# **PORTION 91 OF FARM MATJESFONTEIN NO.304**

## **RESPONSE TO COMMENTS AND OBJECTIONS RECEIVED**

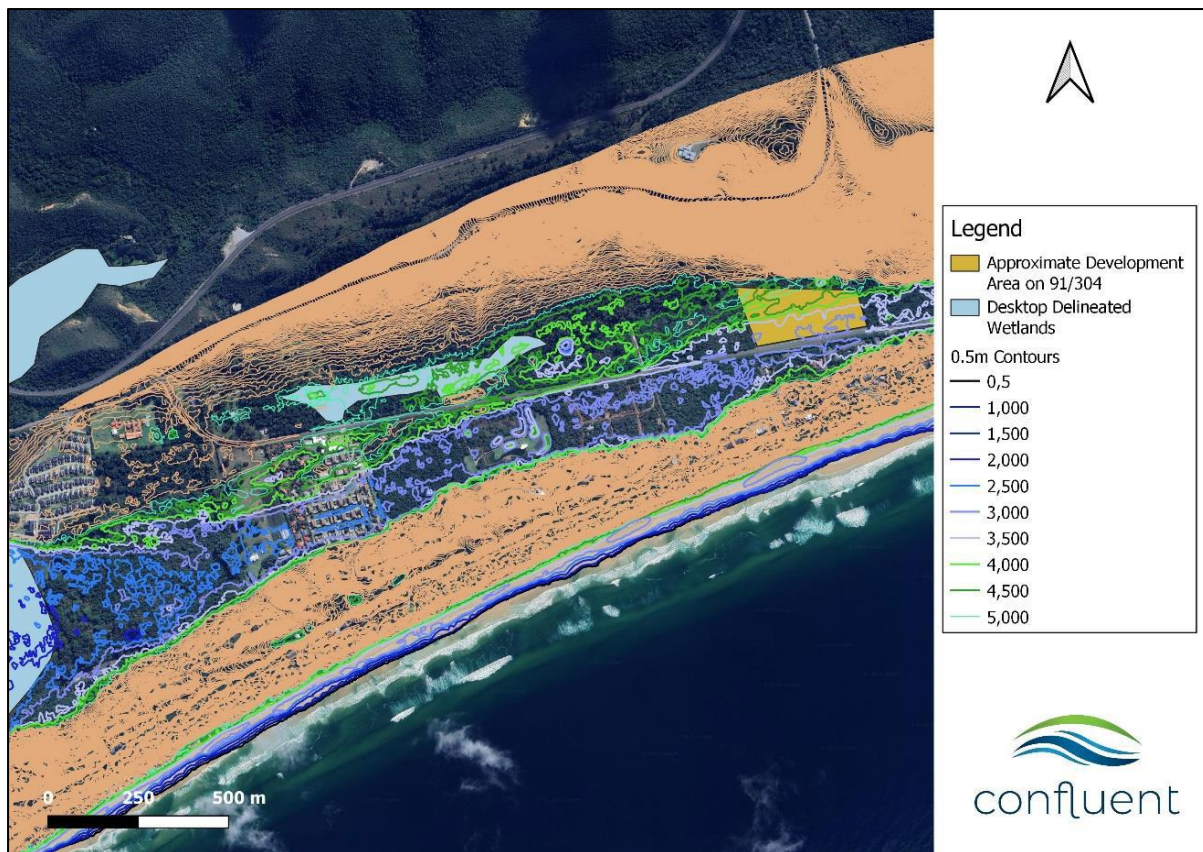
As mentioned before, the road itself acts as a barrier at 3.65m between the south (where any flooding would originate) and the north (the development area). It can be seen from the figure below that any floodwaters from the Keurbooms would theoretically move east, but remain mostly south of the Keurboomstrand Road. During severe flooding in the area in 2007 the highest level reached by floodwaters was The Dunes development at around 2.5m amsl, about 1.1km west of the property.

The Contour Plan confirms that any flooding would come from the south (Milkwood Glen side) and move towards Portion 91, not the other way around. But this would likely be stopped by the road. This is most likely why the 1:100-year flood line is indicated as stopping south of the road. The proposed development can, therefore, not result in the flooding of the surrounding area.
